Technical Service Bulletin: tsb100297

New Connecting Rods

This Service/Parts Announcement introduces new connecting rod assembly, Part Number 3635126.

Improved Serration Surface

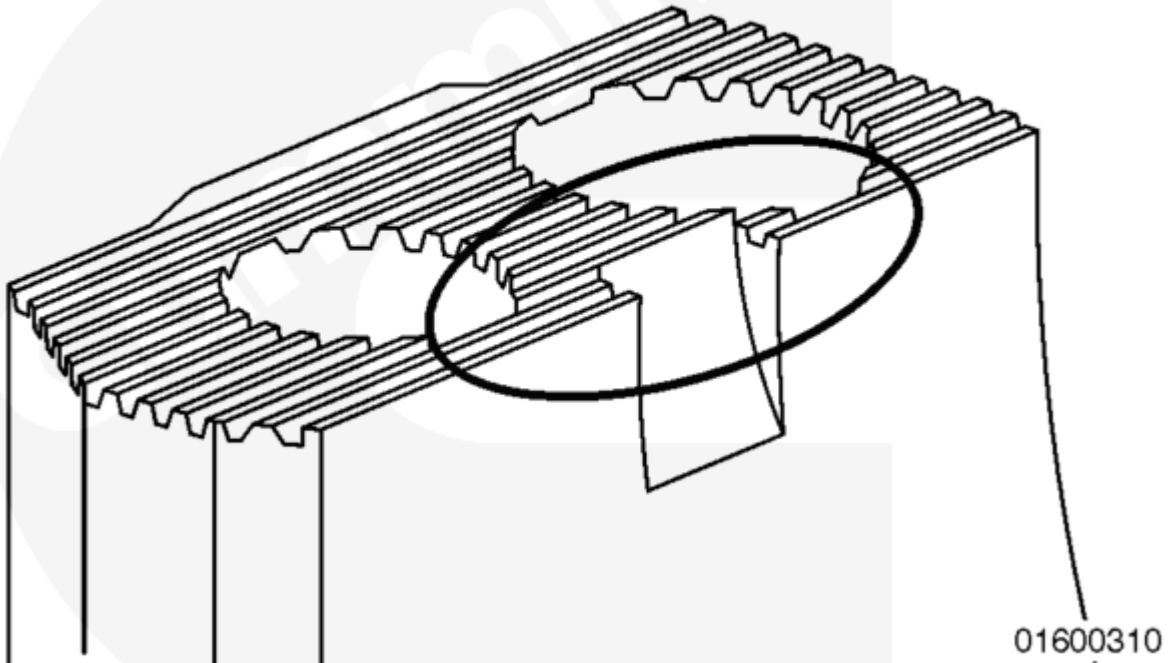
The new connecting rod assembly is more robust. It features more serrated surface, with the serrations' slope angle optimized. These modifications increase the strength of the connecting rod. The new assembly also features new spring-type dowels that replace the old solid-type ring dowels, to be sure of more evenly distributed bolt pre-load at the time of assembly.

The new connecting rod assembly, Part Number 3635126, supersedes assembly, Part Number 3171061. No stock of the old connecting rods is left in factory production, as of February 2, 2004. Please replace all entries of assembly Part Number 3171061 with assembly Part Number 3635126 on hard copies of the QSK45 and QSK60 Parts Catalogs.
